APPEAL SUMMARY

Appeal ID: 26453	Project Address: 1336 E Burnside
Hearing Date: 1/26/22	Appellant Name: David Mullens
Case No.: B-011	Appellant Phone: 360 518 6985
Appeal Type: Building	Plans Examiner/Inspector: Maureen McCafferty
Project Type: commercial	Stories: 5 Occupancy: R-2, B, M, A, S-2 Construction Type: V-A
Building/Business Name: 14th and Burnside	Fire Sprinklers: Yes - NFP13 Throughout
Appeal Involves: Erection of a new structure	LUR or Permit Application No.: 19-139209-CO
Plan Submitted Option: pdf [File 1] [File 2]	Proposed use: Multi Use

FIRE LIFE SAFETY PLAN - FIFTH FLOOR

SE 14TH & BURNSIDE APARTMENTS

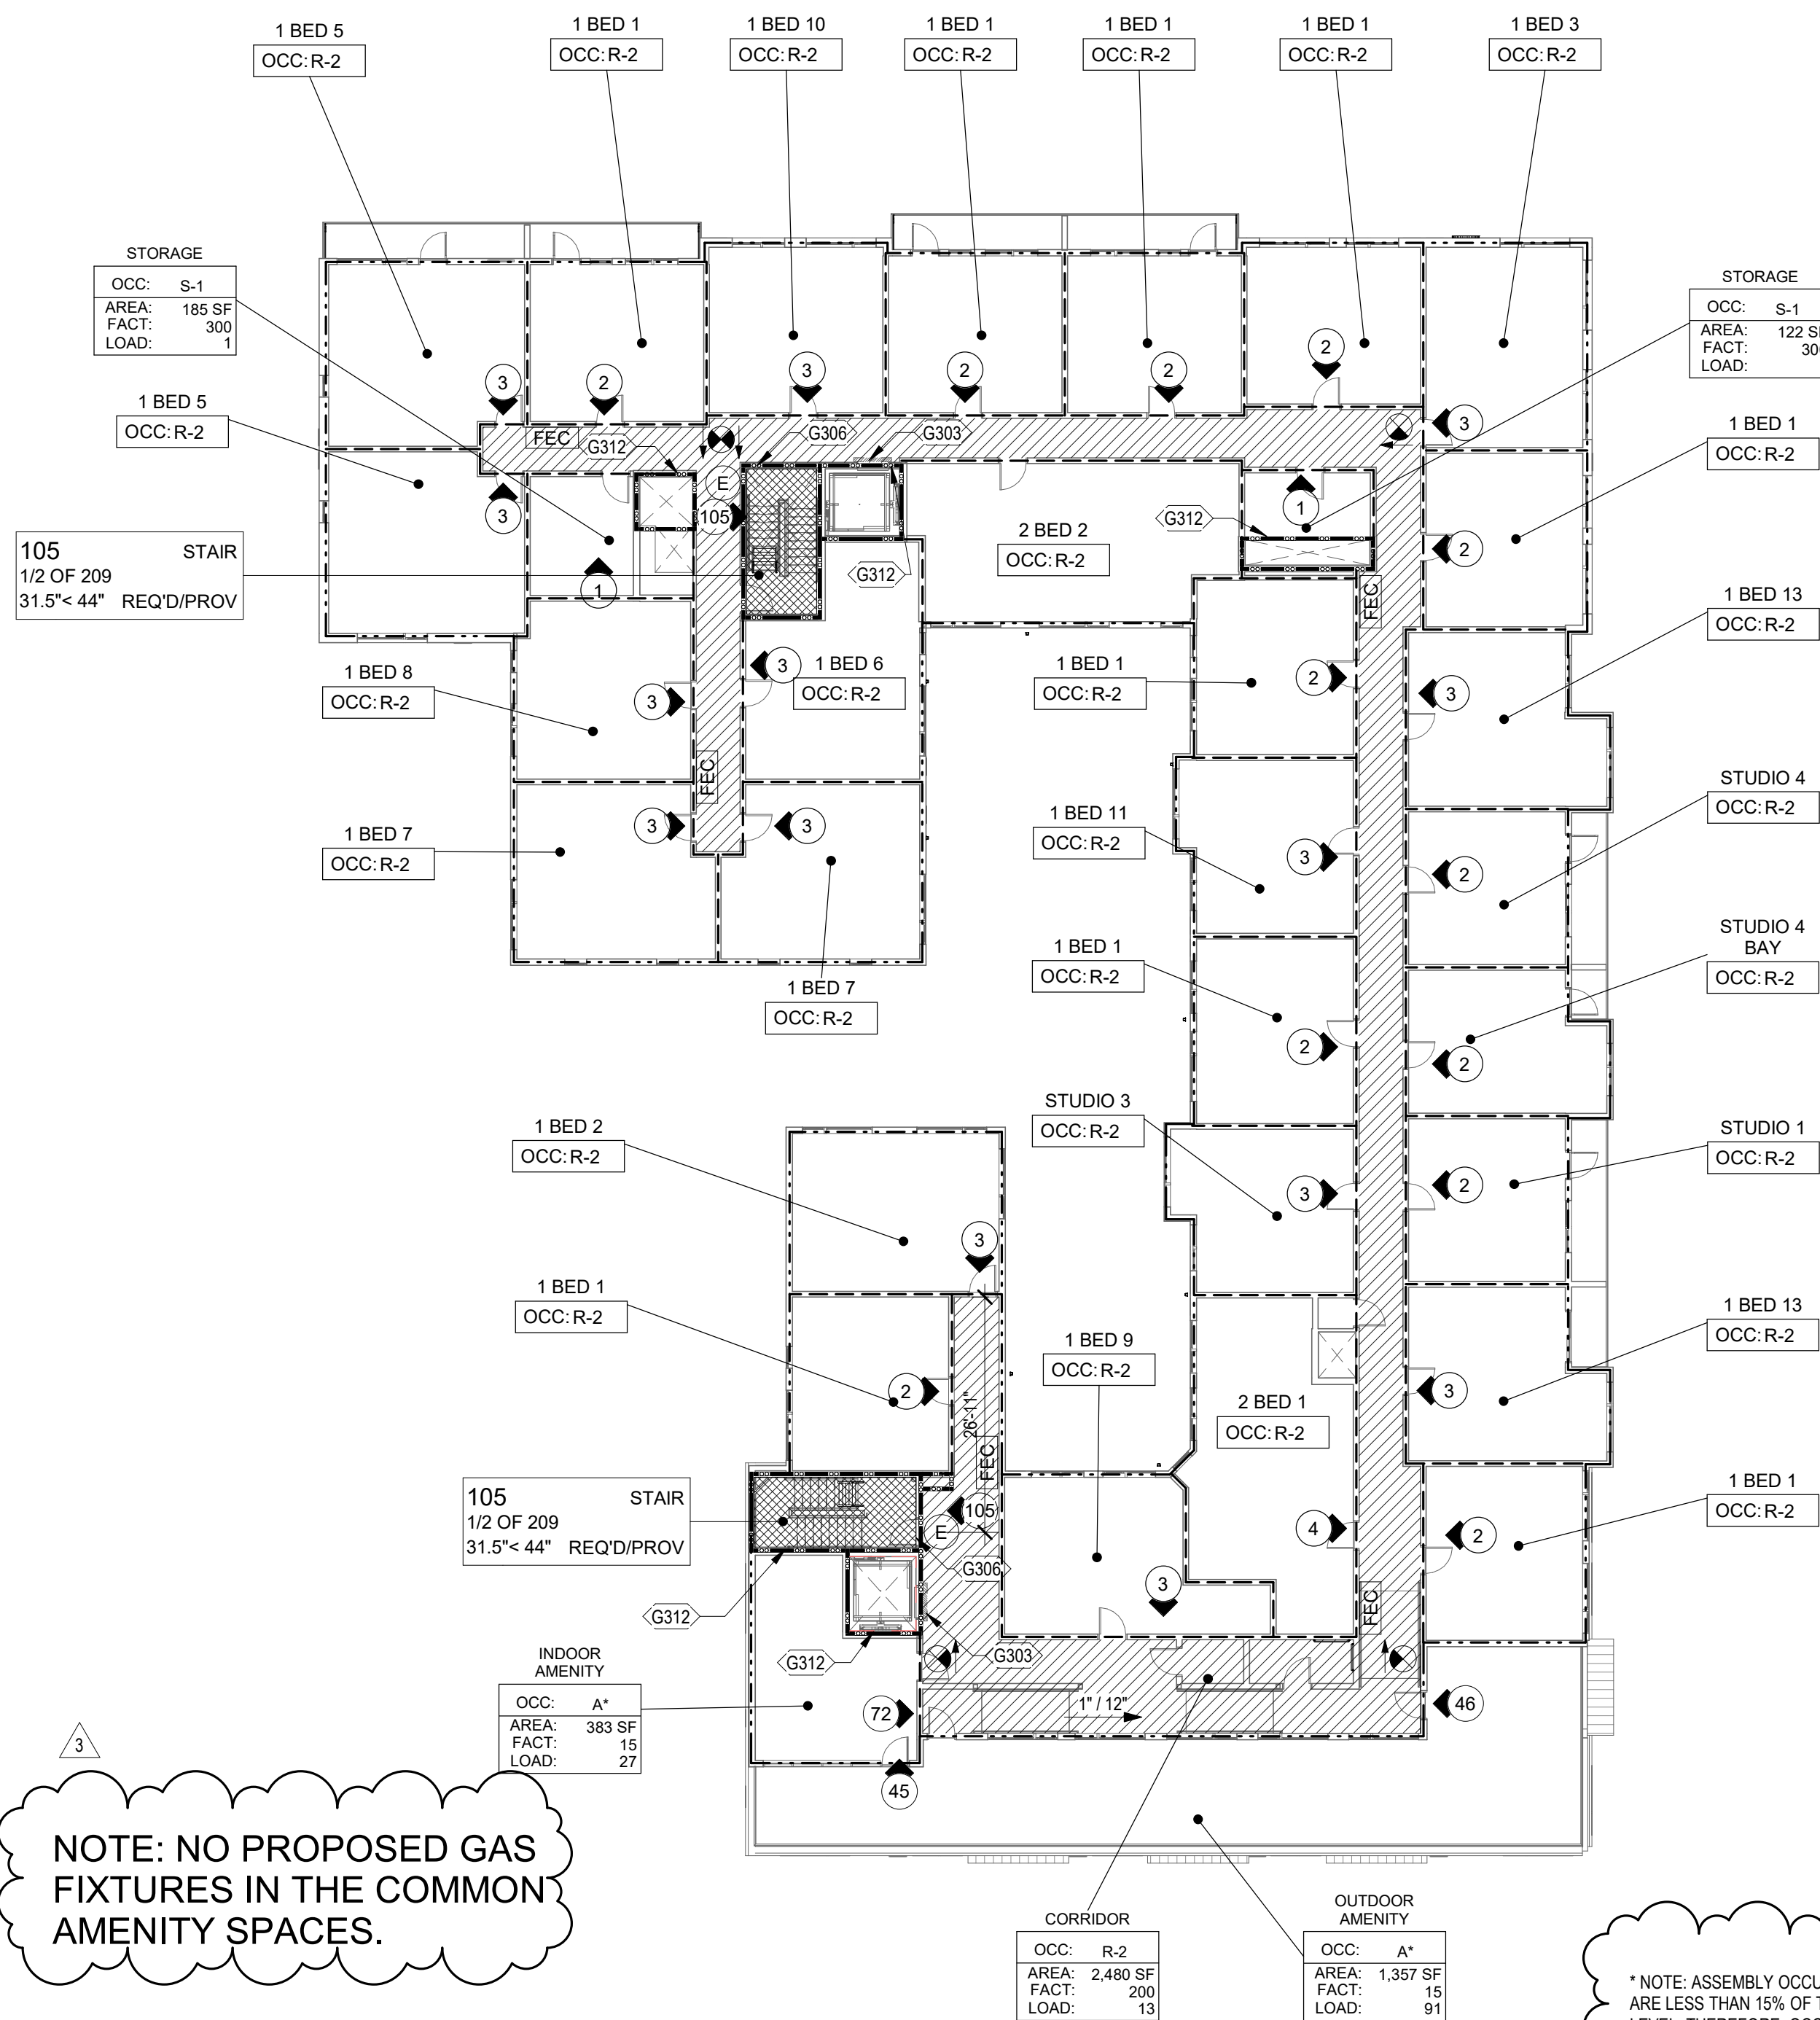
Code Section 2014 OSSC Table 503

Requires Assembly occupancy of sprinklered building limited to 3rd floor of Type VA building

Code Modification or Alternate Requested We request an exception for an occupied roof terrace at the 5th level (4th level of VA portion).

Proposed Design We propose a mixed use building with 143 apartments, ground floor commercial, and subterranean parking. The building is a podium style with 4 floors of VA over 1 floor (plus 2 basement floors) of IA. The 5th floor features an outdoor assembly occupancy of approximately 1,357 SF that will be for use by the residential tenants only. The building is to be equipped with a full NFPA 13 sprinkler system. The elevator serving this level is on emergency power. The automatic fire alarm system is to be connected with smoke detectors and to flow & tamper switches in sprinkler system. Activation of smoke detectors or tamper flow switch in sprinkler system to operate emergency voice/alarm communication system.

Reason for alternative The owner desires to provide a deck and garden on the roof as an amenity to the residential tenants, providing financial viability to the project. The roof level, though categorized as an assembly occupancy, can be considered, in this instance, an accessory use to R-2, used for the residents only. Furthermore, recent changes to the OSSC allow assembly on occupied roofs at any level outright.

* NOTE: ASSEMBLY OCCUPANCIES ON 5TH FLOOR
ARE LESS THAN 15% OF TOTAL AREA OF THIS
LEVEL. THEREFORE, OCCUPANCY IS CONSIDERED
ACCESSORY TO R-2.

Occupied roof terrace located above maximum allowable height: Granted provided compliance with 2018 OSSC Section 503.1.4, Exception 1 is verified at time of plan review.
